Re: Champion Xpress Car Wash
1520 Juan Tabo Blvd. NE
Traffic Circulation Layout
Engineer's Stamp 11-03-21 (J22-D071)

Based upon the information provided in your submittal received 11-03-21, the above referenced plan cannot be approved for Building Permit until the following comments are addressed:

Sheet:
TRAFFIC
CIRCULATION
LAYOUT PLAN

ADA PARKING SIGNAGE
NOT TO SCALE

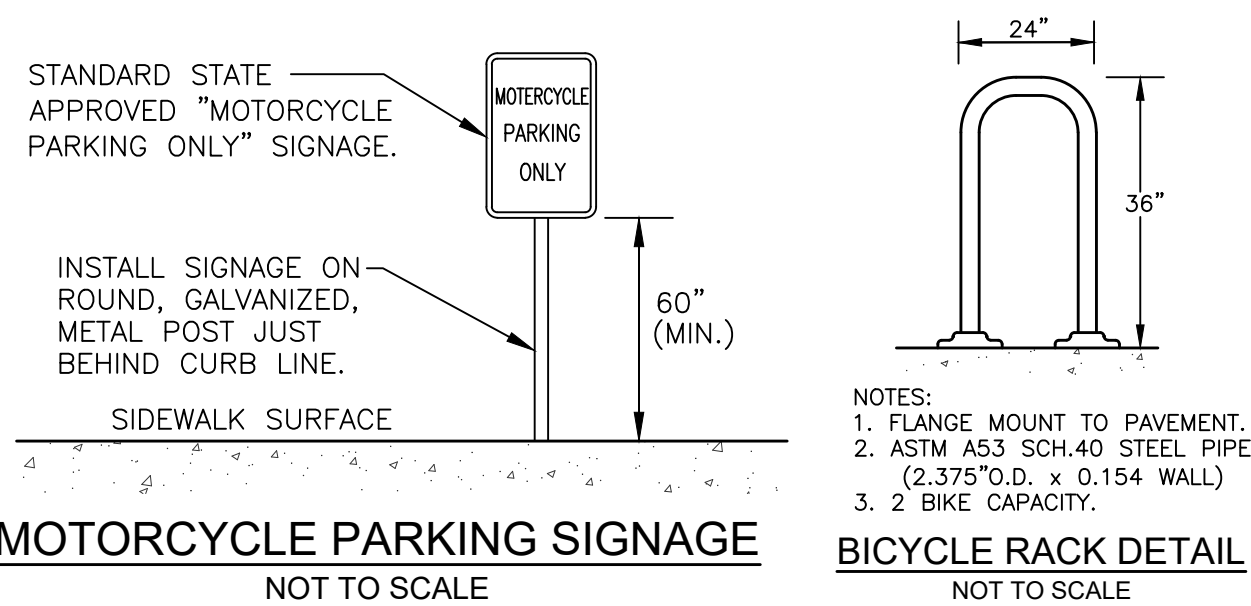
8. The ADA van accessible parking stall bumper and signage are in conflict. Please address this concern.
9. Princess Jeanne Ave. Entrance
- Provide entrance details. Reference COA standard DWG.

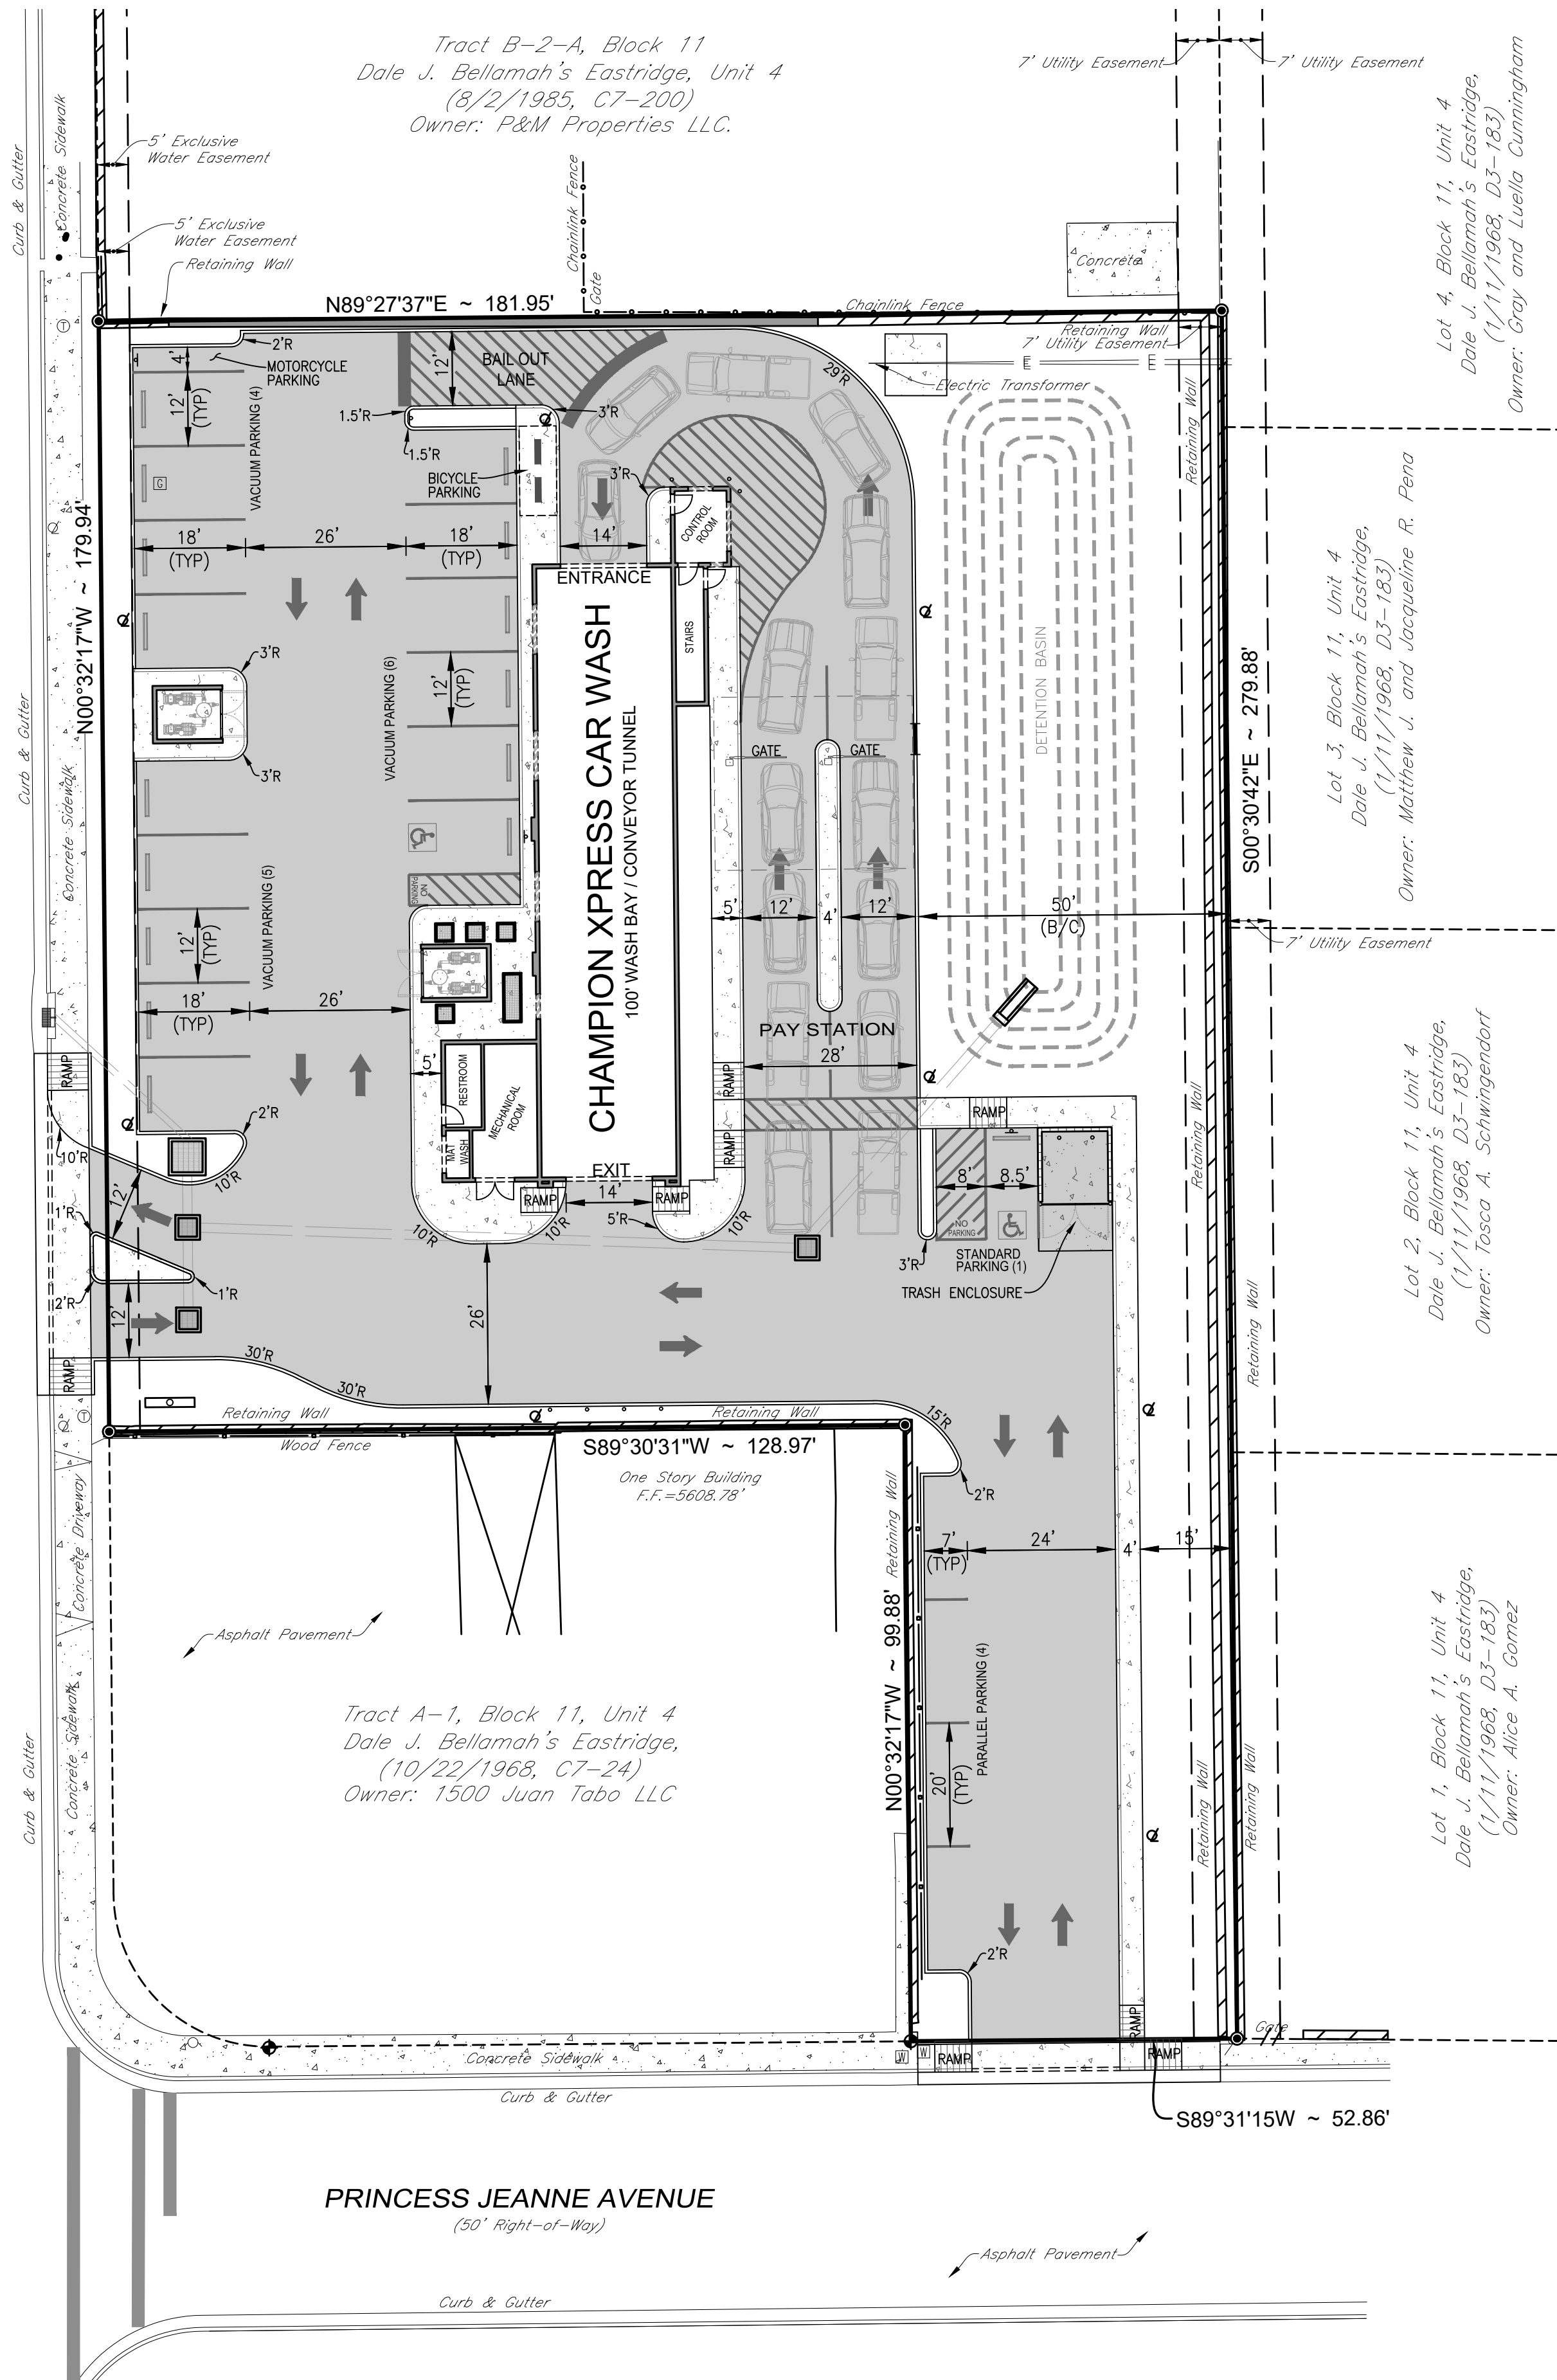
1. List the number of parking spaces required by the IDO as well as the proposed number of parking spaces including bicycle and motorcycle parking.
2. Identify all existing access easements and rights of way width dimensions.
3. Identify the right of way width, medians, curb cuts, and street lanes widths on Juan Tabo.
4. Maximum access width for arterial, collector, and local streets are as follows:

- Juan Tabo is Principal Arterial.
5. Jaun Tabo Proposed Entrance:
 - Provide entrance details. Reference COA standard DWG.
 - The proposed entrance Island needs to located on the private property. Is this Island will obstruct the efficiency of egress and ingress traffic?
 - Provide the dimension from the face of the curb to the adjasent property line.
 - Provide existing sidewalk width.
 - Please verify if there will be any conflict between northren leg segment of driveway access and existing Stormwater Inlet.

- Southern leg driveway: Please verify if there will be any interfere between proposed ADA ramp and adjacent property line.
 - It appears you are proposing a tight radius. Per DPM curb return radius is 15 ft for cars only. Radius for delivery trucks, fire trucks, etc. is 25 ft. or larger.
6. Please list the width and length for all existing and proposed parking spaces. Some dimensions are not shown.
7. The minimum parking stall dimensions are:

- Due to the limited space, provide paving strips (for NO parking allowed) at the 4th parallel parking space adjacent to the entrance.
10. Label the motorcycle parking spaces by placing (MC) on the pavement of each space.

15. A 5 ft. keyway is required for dead-end parking aisles.

16. Per the IDO, a 6 ft. wide ADA accessible pedestrian pathway is required from the public sidewalk to the building entrances. Please clearly show this pathway and provide details.

17. Per DPM, a 6 ft. wide ADA accessible pedestrian pathway is required from the ADA parking stall access aisles to the building entrances. Please clearly show this pathway and provide details.

21. The minimum drive through lane width is 12 feet with a 25 foot minimum radius (inside edge) for all turns. (A 15 foot radius can be used with an increase in lane width to 14 feet). Please dimension all lane widths and radii.

22. All one-way drives shall have "One Way" and "Do Not Enter" signage and pavement markings. Please show detail and location of posted signs and striping.

23. Provide details for all pavement markings and striping.
24. Please provide a sight distance exhibit
25. Show the clear sight triangle and add the following note to the plan: "Landscaping and signage will not interfere with clear sight requirements. Therefore, signs, walls, trees, and shrubbery between 3 and 8 feet tall (as measured from the gutter pan) will not be acceptable in the clear sight triangle.
